Tennessee Valley Authority, 1101 Market Street, Chattanooga, Tennessee 37402-2801

April 7, 2006

**BROWNS FERRY NUCLEAR PLANT (BFN) UNITS 1, 2 AND 3 - RESPONSE
TO FISH & WILDLIFE SERVICES' (F&WS) REQUEST FOR ADDITIONAL
INFORMATION (RAI) ON NRC'S BIOLOGICAL ASSESSMENT OF TVA'S
APPLICATION FOR BFN LICENSE RENEWAL**

Figure 1. Survey Results of Threatened and Endangered Fresh Water Mussel Species Conducted in Wheeler Reservoir since 1978.

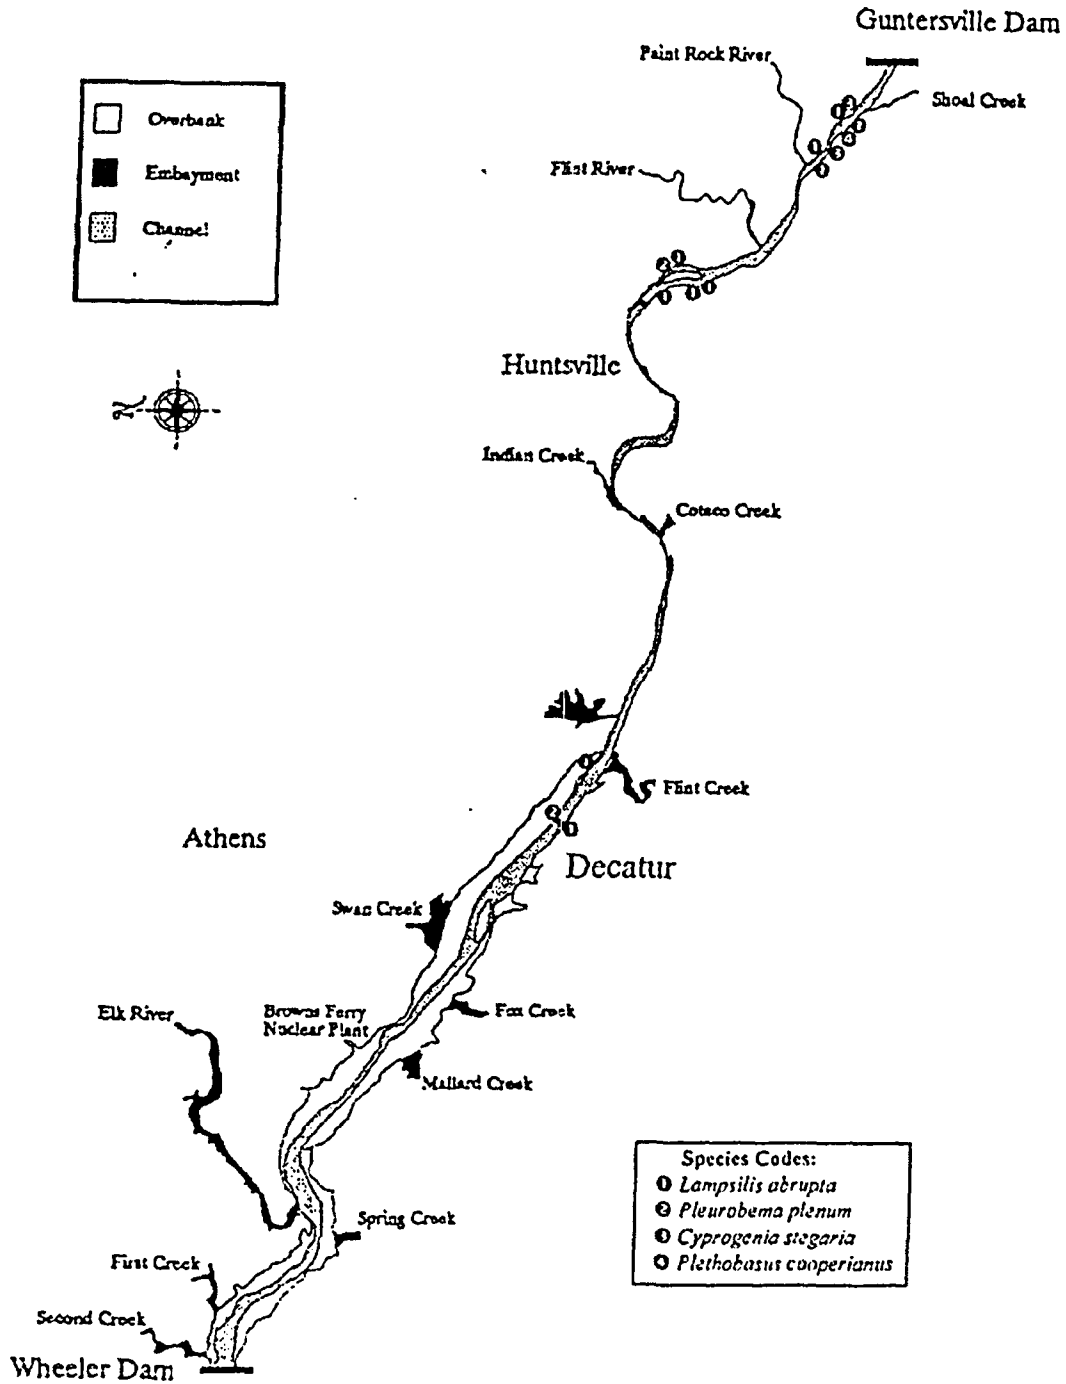
Provide some discussion on the thermal plume produced by BFN and whether the thermal plume will/will not affect the host fish for listed mussel species within Wheeler Reservoir.

The four threatened and endangered freshwater mussels (pink mucket, rough pigtoe, orangefoot pimpleback and fanshell) found in Wheeler Reservoir are all primarily located in the riverine section below Guntersville Dam (Figure 1). Known fish hosts for the pink mucket and rough pigtoe are all common reservoir species and are primarily sportfish except for freshwater drum and rosefin shiner (TVA 2005a) (Table 1). The orangefoot pimpleback and fanshell fish hosts are logperch, darters, and sculpins (TVA 2005a). Mettee (1996) reported no records of mottled sculpin, tangerine darters, or blotchside logperch in the highland rim region of Alabama. Rosefin shiners, greenside darters, and banded sculpins are found in tributary streams to Wheeler Reservoir; snubnose and banded darters are only found in the headwaters of the Elk River.

Temperature Distribution on Water Surface

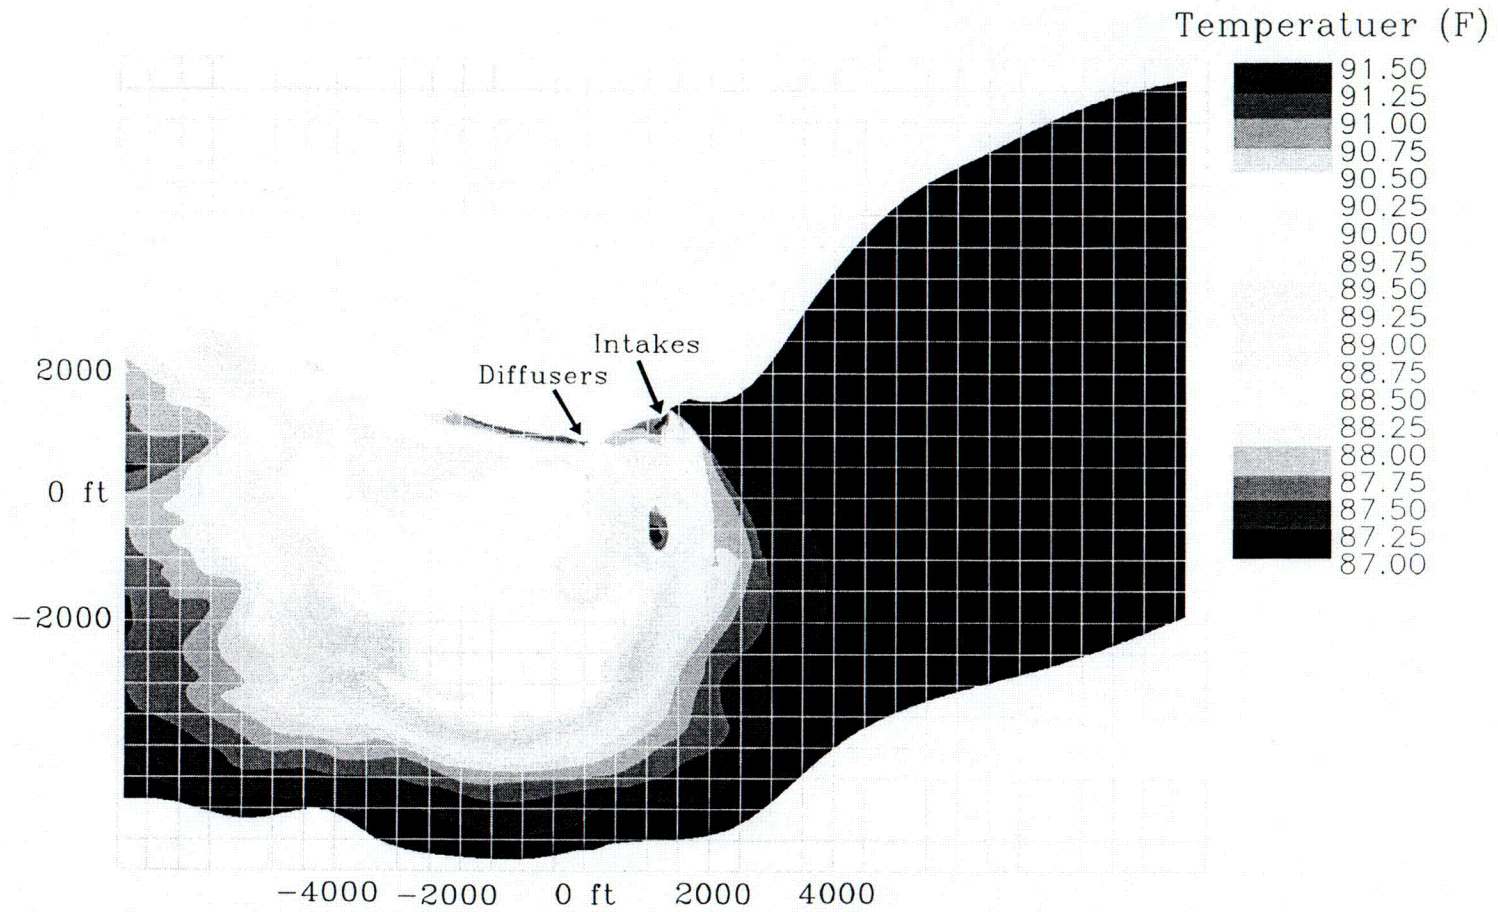
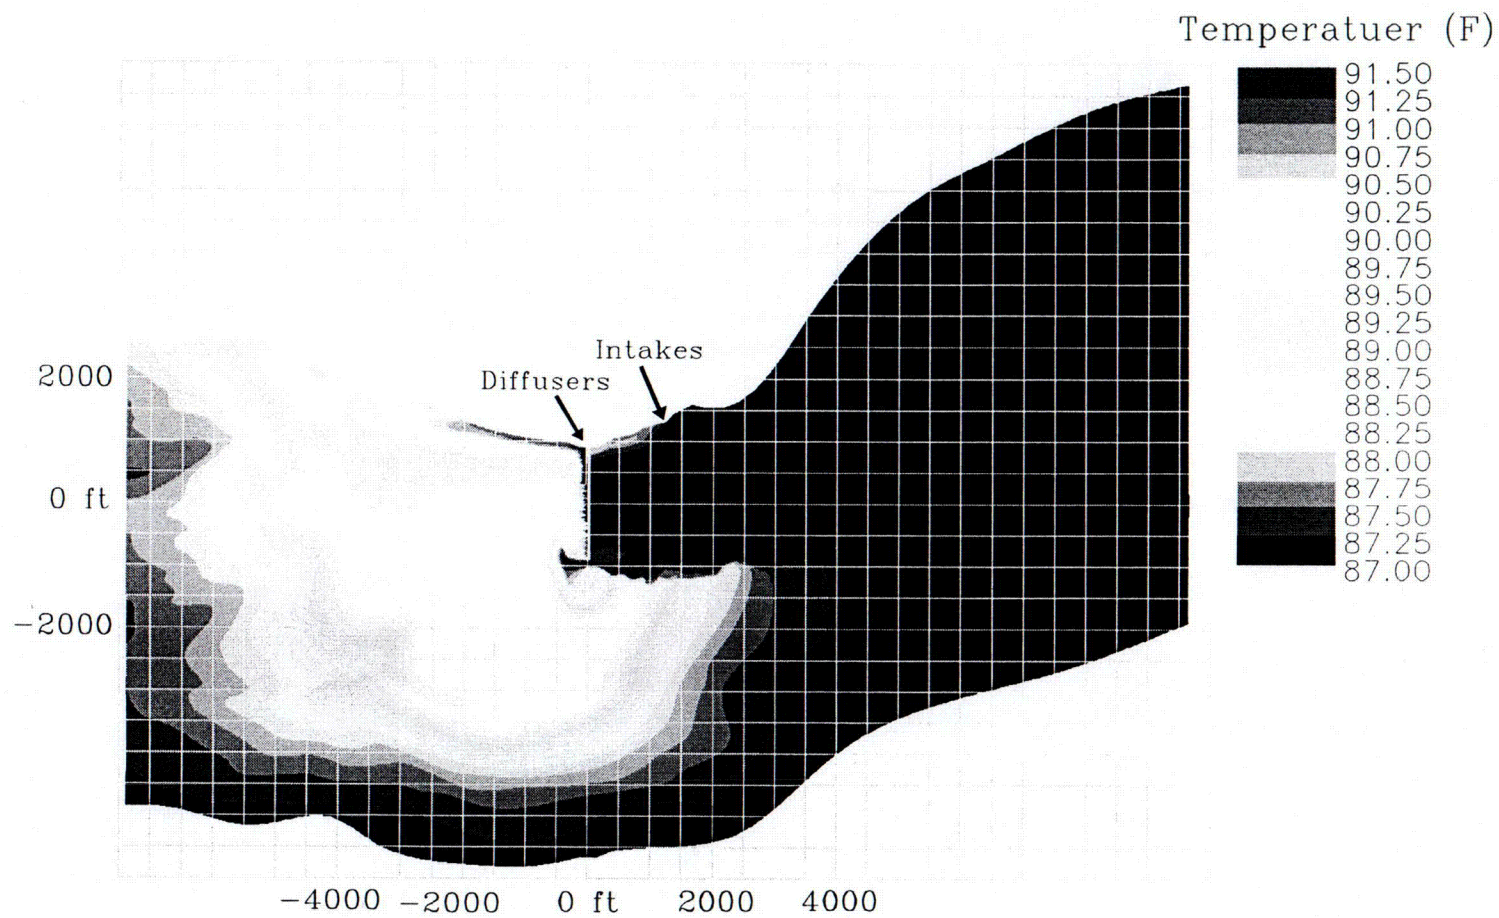
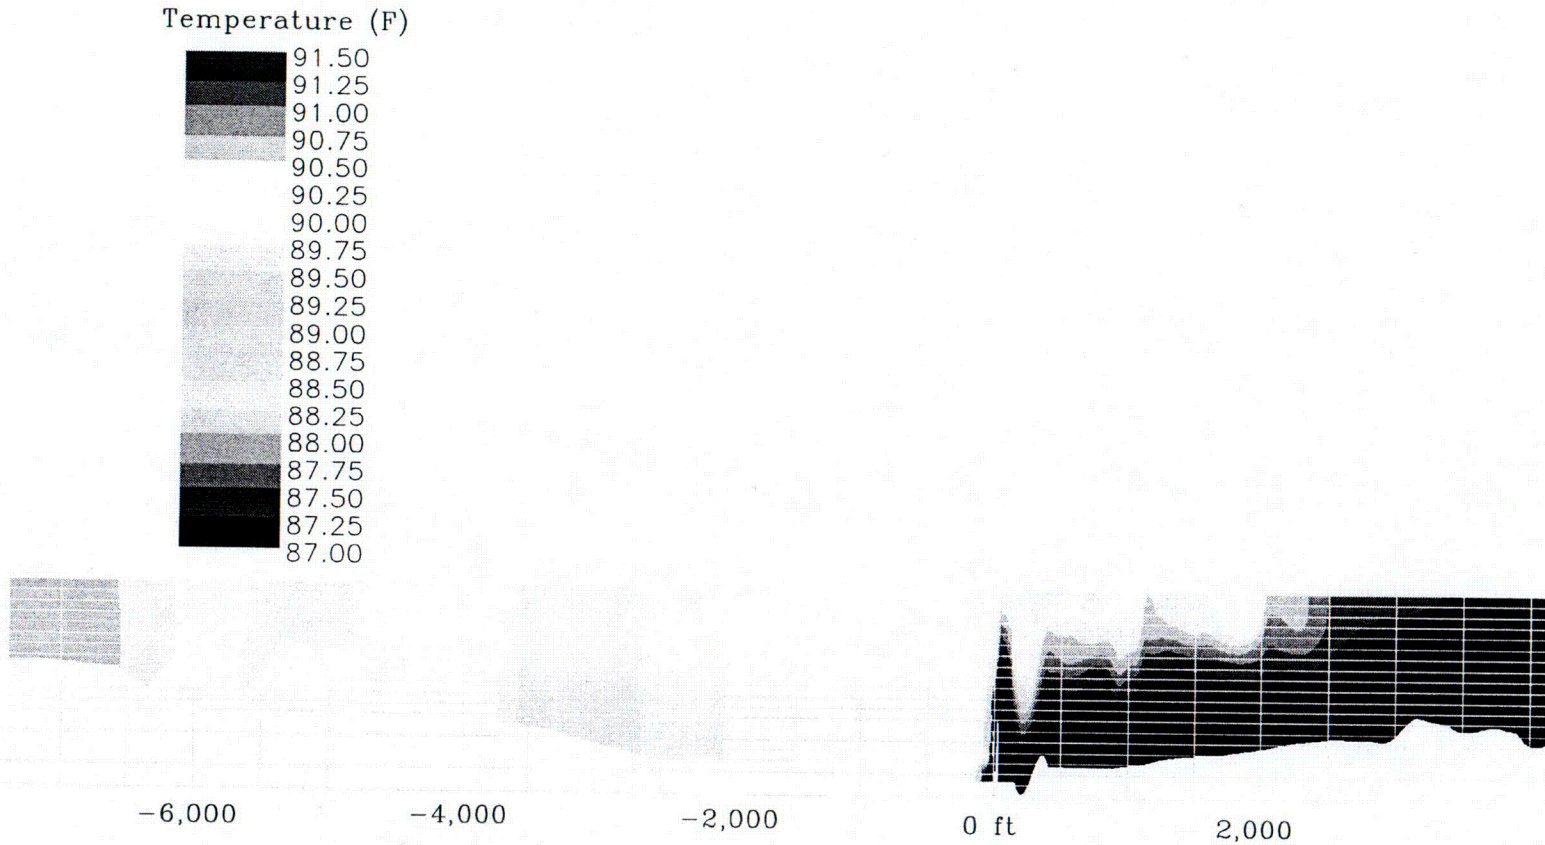
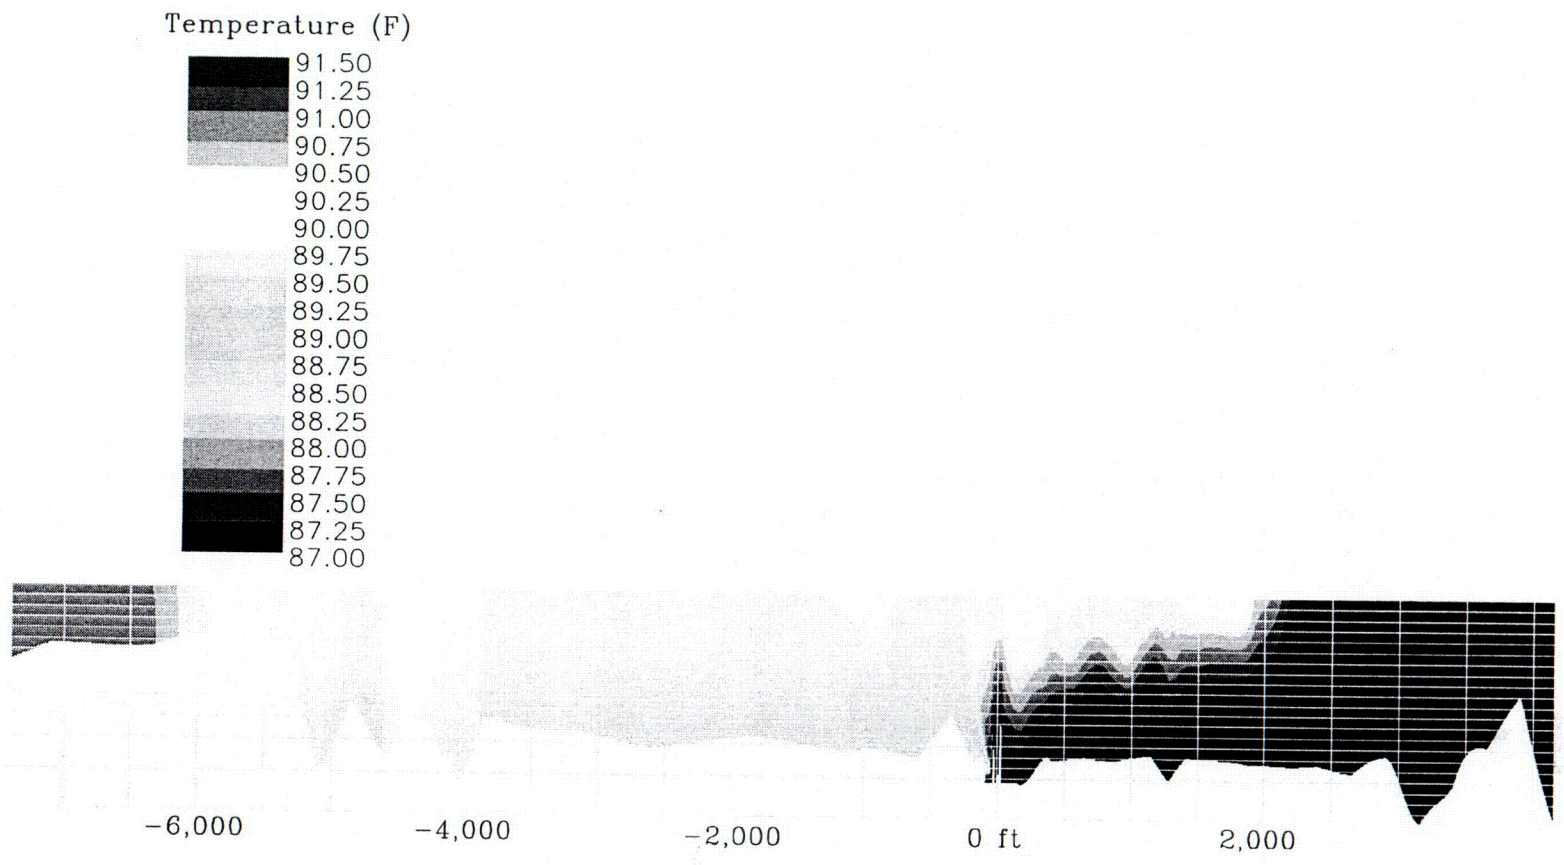
Provide modeling data depicting the thermal plume within Wheeler Reservoir when all 3 nuclear plants are operating at full capacity (120% of their originally licensed power production capacity). Describe any differences expected in the extent of effects on bottom and top waters before and after startup of Unit 1.

Attachment 6 contains a copy of a Power Point presentation showing the results of a three-dimensional simulation of the diffuser thermal effluent with all three units operating at extended power uprate (120 percent of originally licensed thermal power). The presentation is the same as that shown to F&WS in the meeting of October 27, 2005. The river flow is 10,000 cubic feet per second, the minimum daily average flow at BFN for the summer heating season, as targeted by TVA River Operations. The upstream ambient river temperature is 87°F, the approximate maximum temperature allowing sustained operation of BFN at full power without exceeding the maximum river temperature downstream of the plant specified in the NPDES permit. At higher ambient temperatures the plant would have to initiate a derate to protect the NPDES limit.

The results of the three-dimensional simulation represent the worst case scenario for conditions including all three BFN units operating at max generation with extended power uprate. Compared to the operation of Unit 2 and Unit 3, the startup of Unit 1 will increase the volume of waste heat in Wheeler Reservoir. Thus, with Unit 1, the spatial extent of the thermal discharge will be larger, both at the bottom and at the surface of the reservoir. However, the magnitude of the temperature extremes along the downstream boundary of the mixing zone will not change significantly, because of the plant requirements to maintain compliance with the NPDES river temperature limits.
